Access Compliance Report

Public Rights-of-Way

(Curb Ramps)

Intersection ID: 10041631	Main Street: WHITEHALL_PARK_DR	Cross Street: N/A	Location: SW
ADA ID: 491736424EE8	Ramp Type: PerpDiag	Initial Pass/Fail: Fail	Overall Compliance: No
		Severity Score: 12.5	
Codes/Mitigation Info/Possible Solution		Field Measurements/Component Compliance

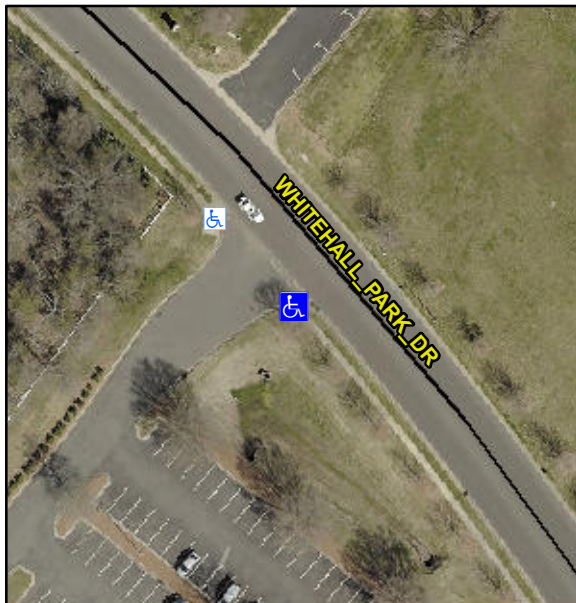
Not Found, R304.5.3

Compliance	Description	Data	Compliance	Description	Data
N/A	Ramp Length (in)	63.0	Yes	Ramp Slope (%)	5.6
Yes	Ramp Width (in)	48.0	No	Ramp XSlope (%)	5.7
N/A	Flare Type LT	N/A	N/A	Flare Type RT	N/A
N/A	Flare Slope LT (%)	N/A	N/A	Flare Slope RT (%)	N/A
N/A	Flare Traversable LT?	N/A	N/A	Flare Traversable RT?	N/A
N/A	Landing Length (in)	N/A	N/A	DWS Provided?	N/A
N/A	Landing Width (in)	N/A	N/A	DWS Contrast?	N/A
N/A	Landing Slope (%)	N/A	N/A	DWS Length (in)	N/A
N/A	Landing X Slope (%)	N/A	N/A	DWS Full Width?	N/A
N/A	Landing Curb? (Y/N)	N/A	N/A	DWS Offset (in)	N/A
N/A	Shared Landing?	N/A			
N/A	Gutter Ponding?	N/A	N/A	Gutter Slope (%)	N/A
N/A	Gutter Lip Ht (in)	N/A	N/A	Gutter X Slope (%)	N/A
N/A	Painted X Walk1?	No	N/A	Painted X Walk2?	No
	X Walk 1 Direction	To NE		X Walk 2 Direction	To NW
N/A	X Walk 1 Width (in)	N/A	N/A	X Walk 2 Width (in)	N/A
	X Walk 1 Slope (%)	2.9		X Walk 2 Slope (%)	1.0
	X Walk 1 X Slope (%)	0.4		X Walk 2 X Slope (%)	4.9

Remove & Replace Curb Ramp With Two New Directional Ramps or Equivalent.
